ADDENDUM #2 Questions and Clarifications

Service Lane Renovation (General Contractor) IFB #FED2019-13

Addendum Number: 02

Project Name: Service Lane Renovation

GPMTD - 2019, PEORIA, IL
XJ404 FRESH WATER VEHICLE WASH SYSTEM
CONCRETE LAYOUT

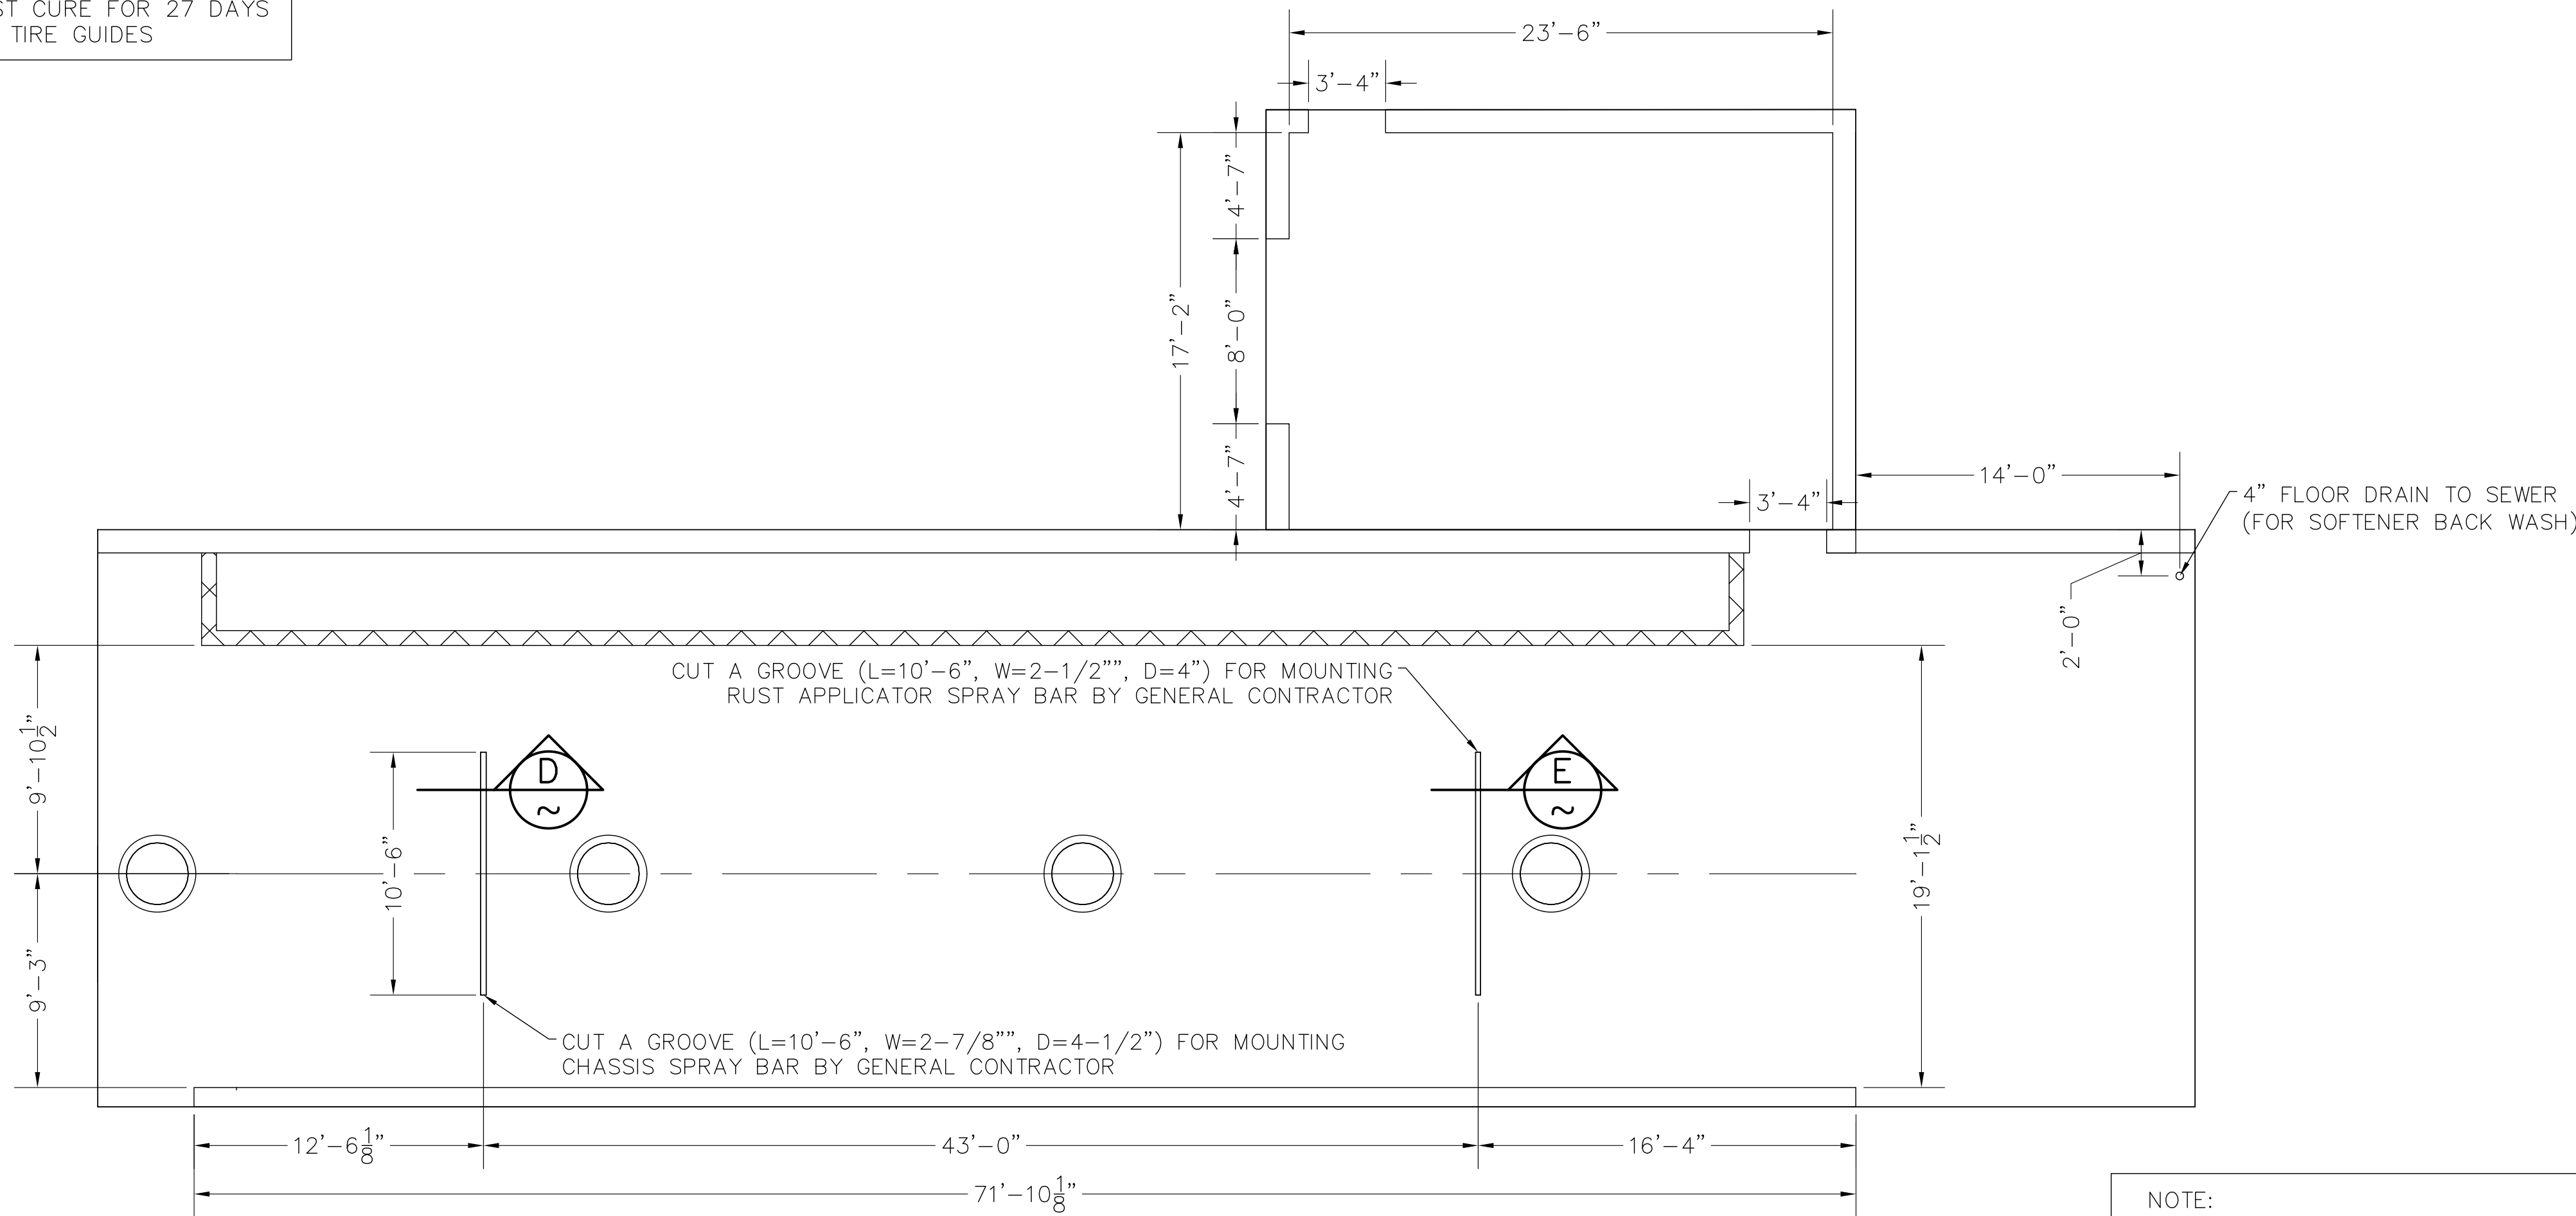
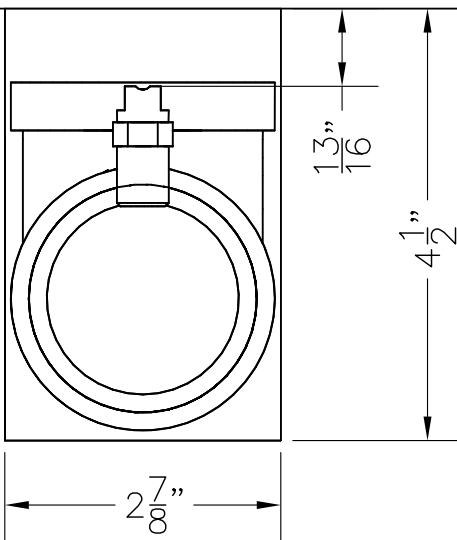
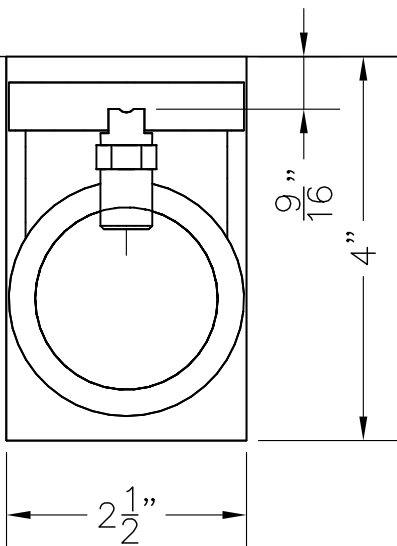
B	10/10/19	Moved SPRAY BAR & TRENCH POSITION	TB	SIL
A	9/26/19	EQUIPMENT RELOCATED	TB	SIL
R.	DATE	DESCRIPTION	BY	APPR

GPMTD - 2019, PEORIA, IL
XJ404 FRESH WATER VEHICLE WASH SYSTEM
UNDERGROUND CONDUITS

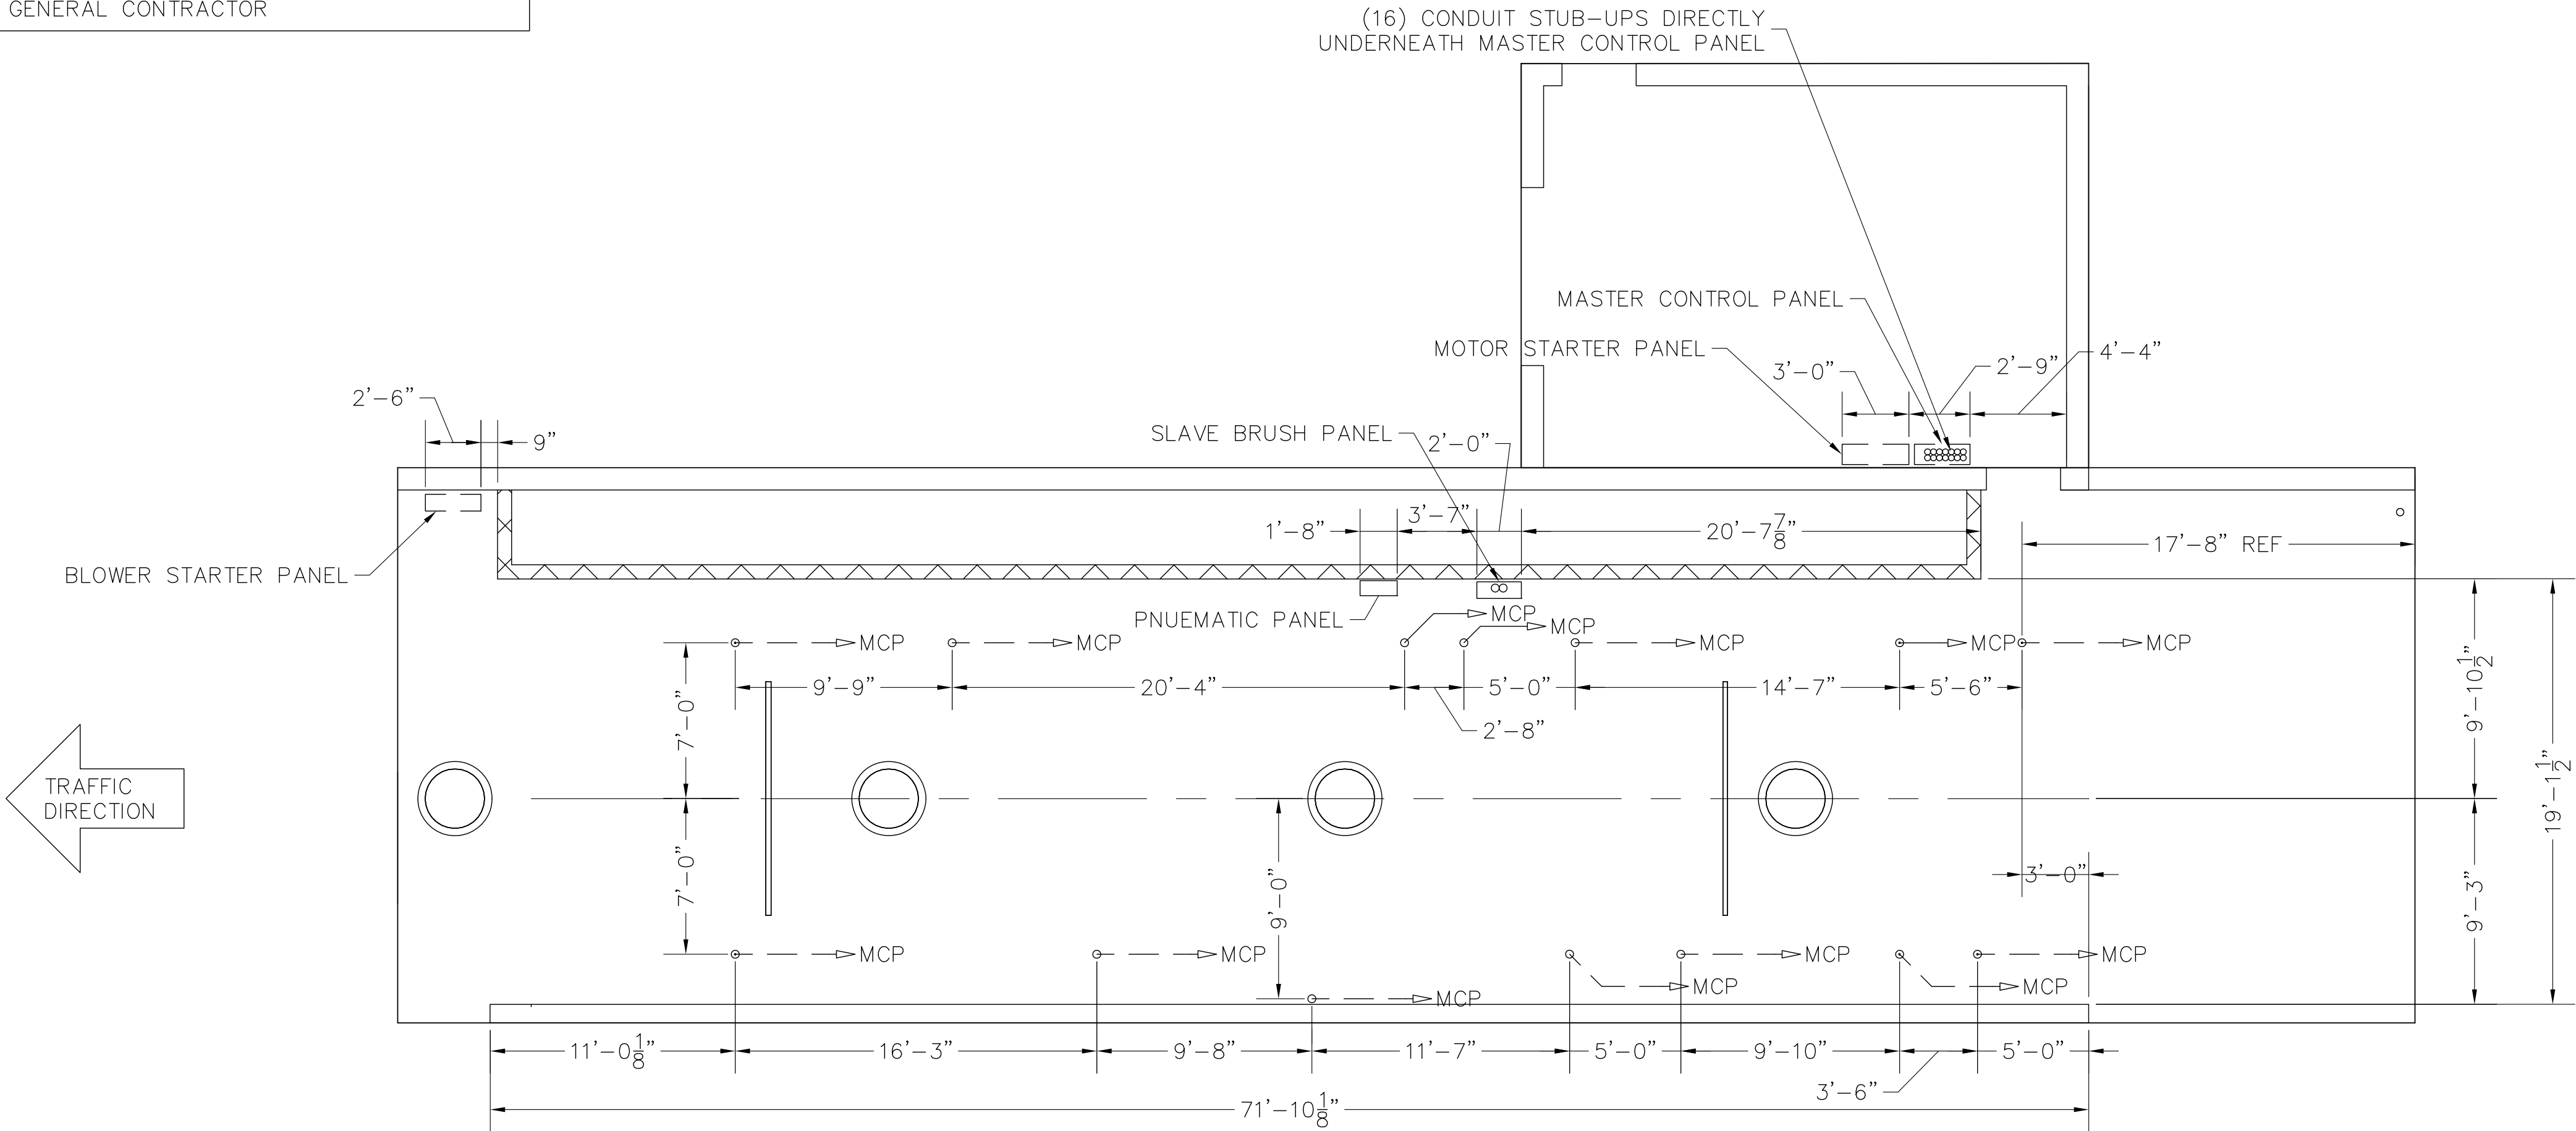
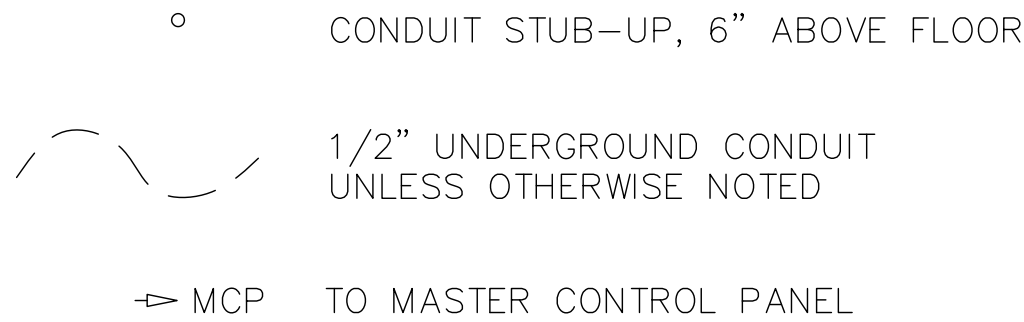
B	10/10/19	MOVED SPRAY BAR & TRENCH POSITION	TB	SIL	
A	9/26/19	EQUIPMENT RELOCATED	TB	SIL	
R	DATE	DESCRIPTION	BY	APPR
